**From:** [REDACTED]  
**Subject:** Springs serving Tan-y-Mynydd  
**Date:** 20 January 2025 10:45:41  
**Attachments:** [Mona Offshore Wind Project](#)  
[MWF Springs serving TYM 150125.pdf](#)

SPRINGS SERVING  
TAN-Y-MYNYDD TROUT FISHERY.

OBSERVATIONS OF 15 JAN 2025

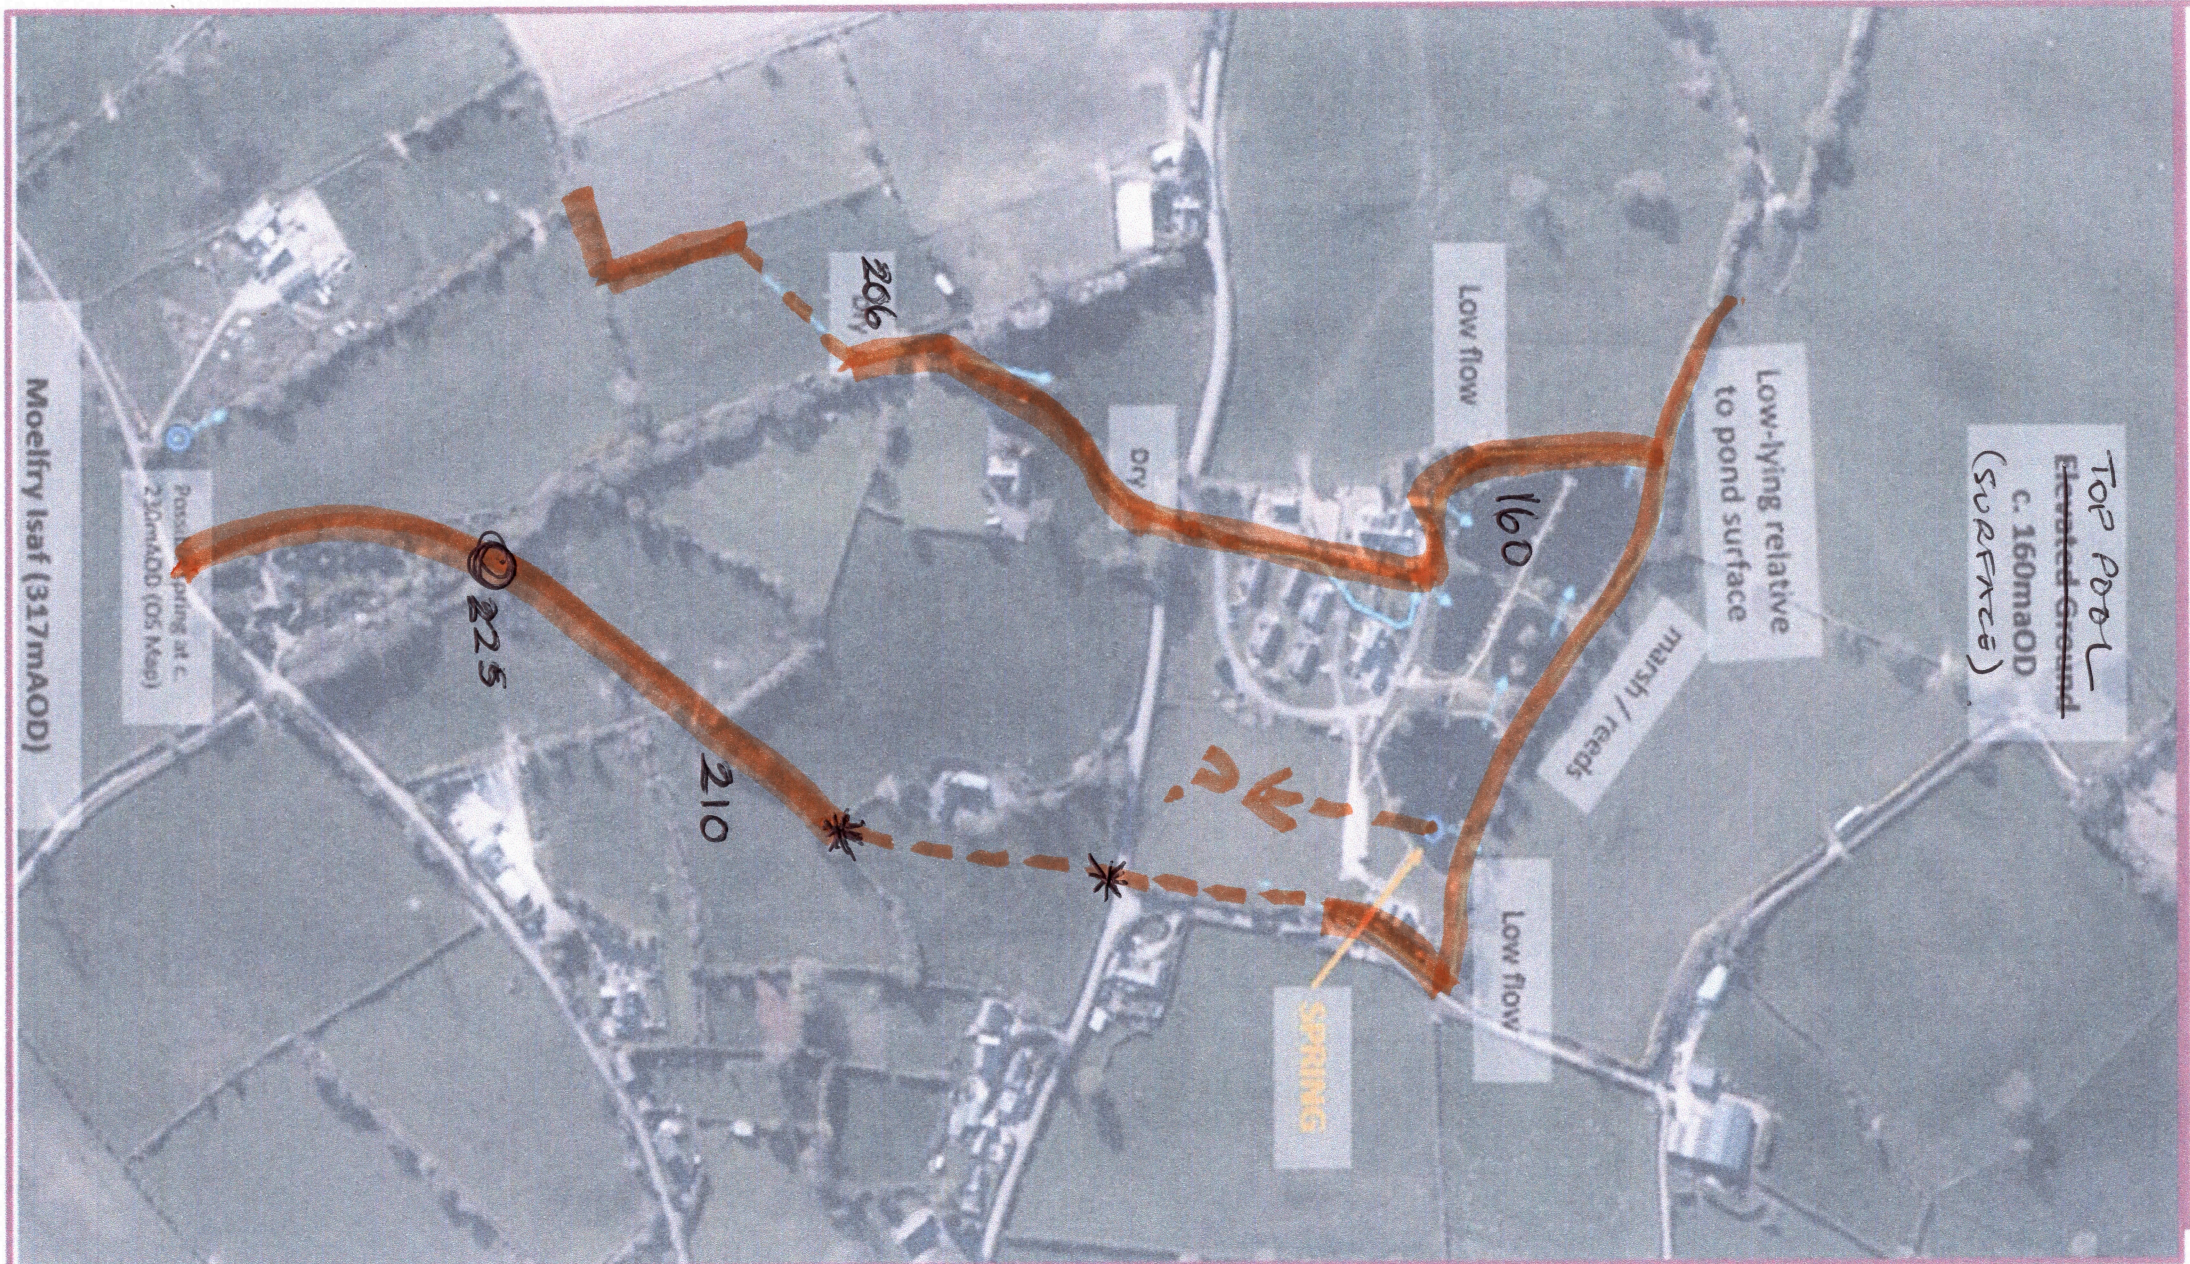
Please find attached a marked up image from your HHRA indicating the routes and points of emergence /disappearance above ground of the springs I walked last Wednesday 15th January 2025.

1. The total absence of any above ground trace for the spring that serves Top Pool
2. The apparent stretch of underground route of the spring that serves the brook to the East of the fishery. Immediately to the South of the B5381 there is clearly evidence (sound of running water and limited visible water) that there is an underground route off Moelfre Isaf that then enters a culvert which looks to cross the road and then stays underground until it reaches the boundary in the South East corner of the fishery.
